Re: Edgley Construction: Jenkins, Charles | Detached Garage

This letter is in reference to inspection issues on the above referenced project.

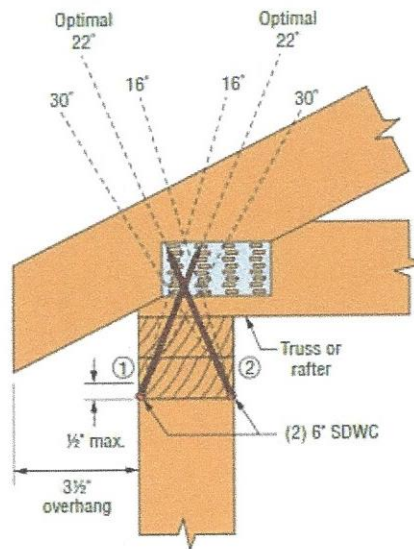
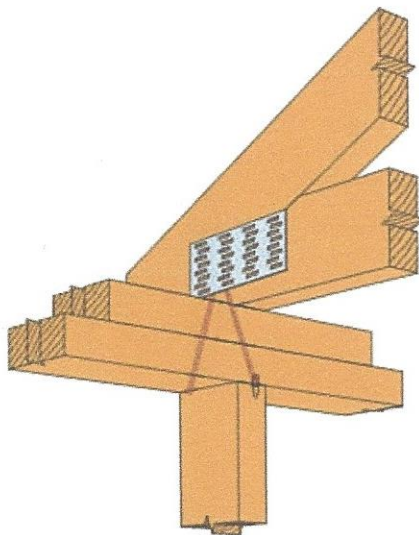
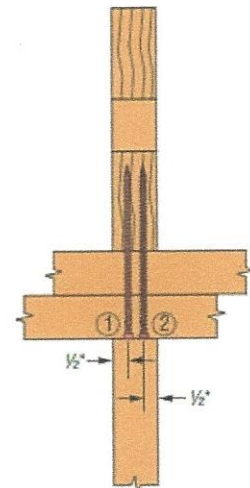
1. On the engineering we called for a drag load connector to be installed on truss T08. This could not be installed because of trusses in the way. Below is the fix.
 - a. Hold down truss T08 with (4) Simpson SDWC15600 screws (2) each ply of truss.
 - b. Install (2) CS20, 14-10d horizontally @ top plates around inside corner under truss.

Configuration C:

Install through Top Plate into Truss/Rafter

Both screws installed at a 16°–30° angle, offset 1/2" from the opposite edges of truss/rafter.
Use metal installation guide included in screw kits for optimal 22° installation.
